Northern Gateway Pipelines Limited Partnership
Section 52 of the *National Energy Board Act* Application for
Enbridge Northern Gateway Project
NEB File OF-Fac-Oil-N304-2010-01 01
Filed 27 May 2010

Information Request No. 3

Engineering

Figure 3.2a – Oil Pipeline Cost of Service Curves

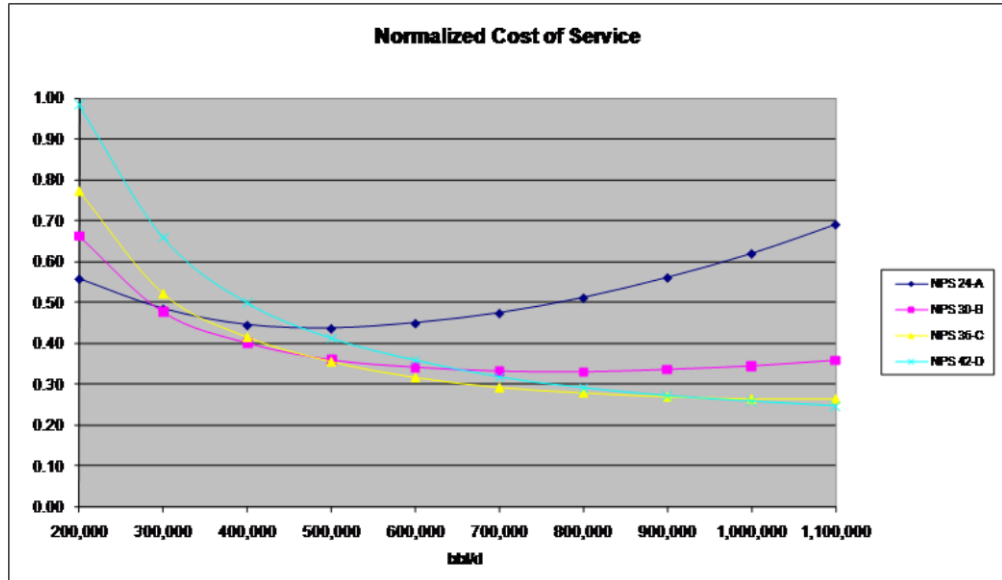
Request: Please provide the following for both the oil and condensate pipeline:

Figures 3.2a and 3.2b illustrate the Normalized Cost of Service curves for the respective oil and condensate pipelines:

The target annual capacities in 100% diluted bitumen service for the oil pipeline system range from an initial of 525 kbpd annual, to an ultimate expansion capacity of up to 850 kbpd annual. The cost of service curves presented in Figure 3.2a (above) show that an NPS 36 pipeline has the lowest cost of service for a flow range between 500 kbpd and 900 kbpd. Therefore, the NPS 36 pipeline diameter was selected as the optimal size for the oil pipeline design.
